SUBJECT: NATIONAL INSTITUTE OF STANDARDS AND TECHNOLOGY – U.S. NUCLEAR
REGULATORY COMMISSION 4TH 2022 QUARTER SUPPLEMENTAL
INSPECTION REPORT NO. 05000184/2022202

National Institute of Standards and
Technology
National Bureau of Standards Test Reactor
Supplemental Inspection Report
No. 05000184/2022202

Figure 1. Refueling tool for latch verification.

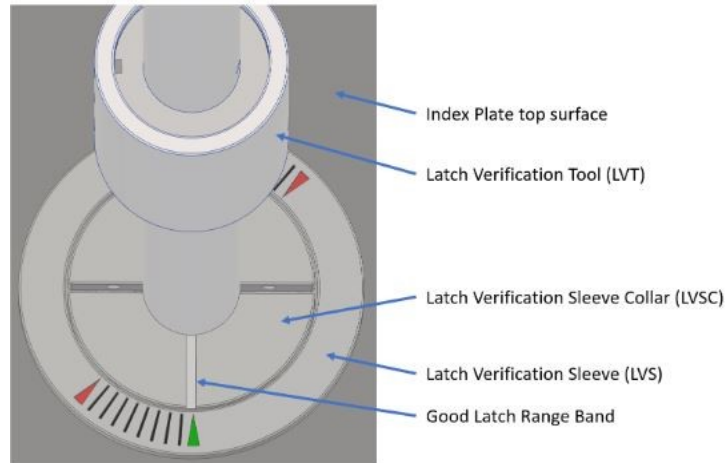
The inspectors reviewed the licensee's assessment of the tools used in refueling to determine if the tools were adequate to meet all new refueling and latch check requirements in accordance with CO section III 1.e.v. This included design change documentation, procedures, PowerPoints, and interviews with individuals involved in the design change.

After the fuel elements are placed in the core and secured, the licensee uses a different refueling tool for rotational latch verification. The tool uses a latch verification sleeve and latch verification sleeve collar as shown in figure 1. The tool gives indication of when an element is in the latched or unlatched position. This change has eliminated the previous technique used by the licensee, prior to the event, which was based on feel by the operator, and replaced it with a quantitative measurement of latch orientation. The licensee performs the verification in accordance with OI 6.1.7, "Rotational Latch Check," and will have a test and measurement program for the tool governed by maintenance procedure (MP) 2.83, "Latch Verification Sleeve and Collar Alignment." The rotational latch verification is followed by an independent video verification.

The inspectors noted that documentation and corrective action of the wear and tear of the refueling tool was implemented into a commenting process in the refueling loading plan sheets. These comments will be addressed to management and dispositioned accordingly. Based on the review of the tools used in refueling, and given the discontinuation of height checks, the inspectors found that the tools are adequate to meet all refueling and latch check requirements.
